Improved Technical Specifications

Quad Cities Station

Volume 12:
Complete CTS Markup

FIGURE 3.4.A-1

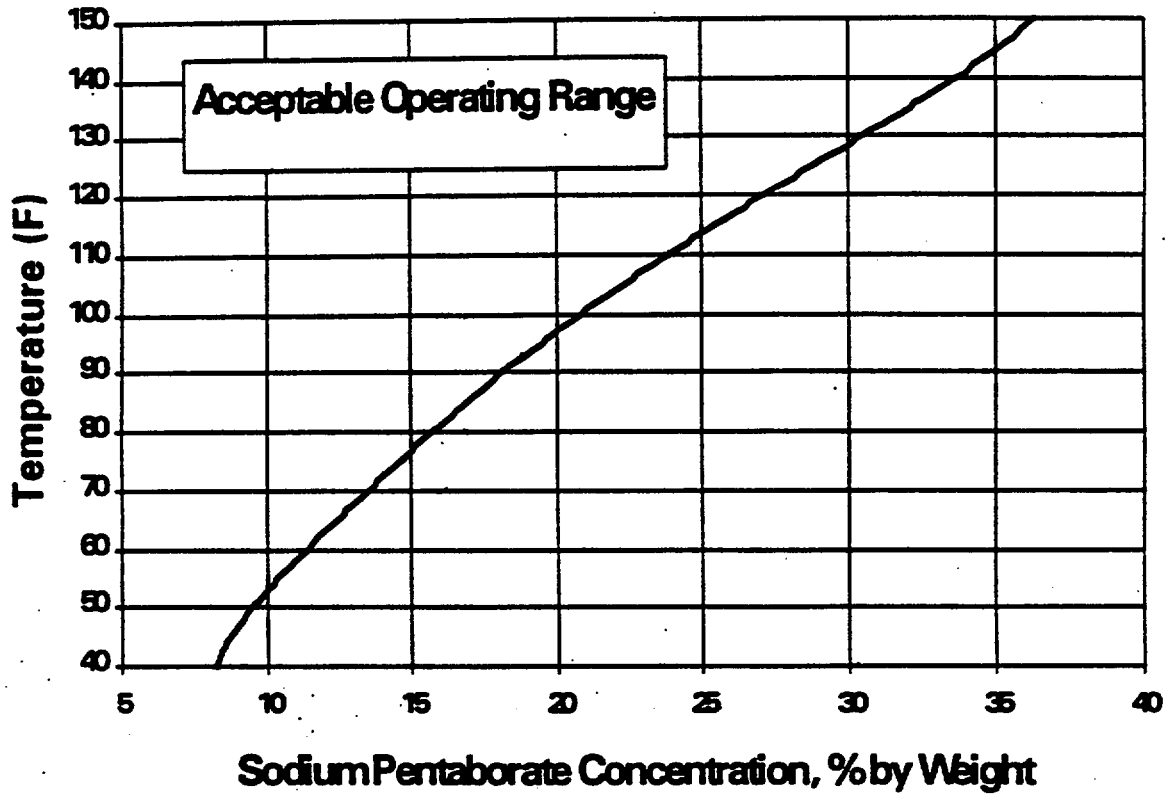
Figure 3.1.7-2

FIGURE 3.6.K-1

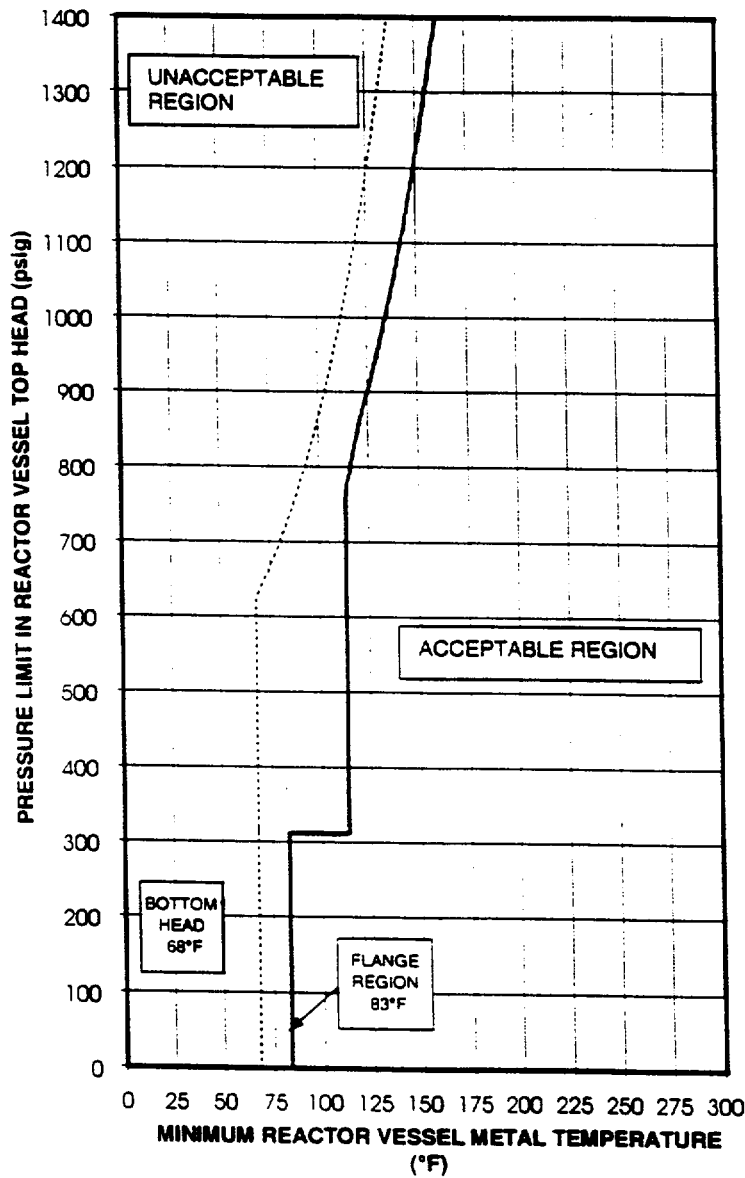
HEATUP/COOLDOWN RATE OF COOLANT $\leq 20^{\circ}\text{F}/\text{HR}$ SR 3.4.9.1
